Docket Number:	15-BSTD-05
Project Title:	2016 Nonresidential Compliance Manual and Documents
TN #:	205923
Document Title:	Robert A. Shearer Comments: NRCA-LTI-03-A Incorrect Instruction(s)
Description:	N/A
Filer:	System
Organization:	Robert A. Shearer, BSEE
Submitter Role:	Other Interested Person
Submission Date:	8/28/2015 4:37:00 PM
Docketed Date:	8/28/2015

NRCA-LTI-03-A Incorrect Instruction(s)

Re: Docket # 15-BSTD-05
2016 Acceptance Testing Forms: Comment 05

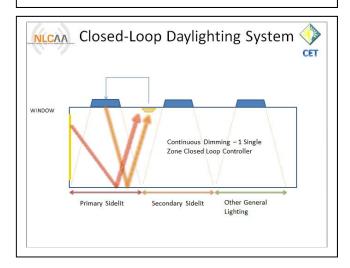
The answer to: What happens if we cover the Sensor is: The lighting should attempt to reach "Full Output".

But ... suppose we cover the sensor under "No Daylight Conditions" and: nothing happens? We are looking at a "Full Output System" ... and the "Reference Illumination" will equal the "Full Output" Illumination.

Therefor: The conditional "If line X = FO" is nonsensical, and this Form Scrap should be deleted.

... You can keep the "or" but delete: "when line I =FO"

Delete "If line h = FO;"

Please see: "EVIDENCE" above and delete the "FO" conditionals shown.
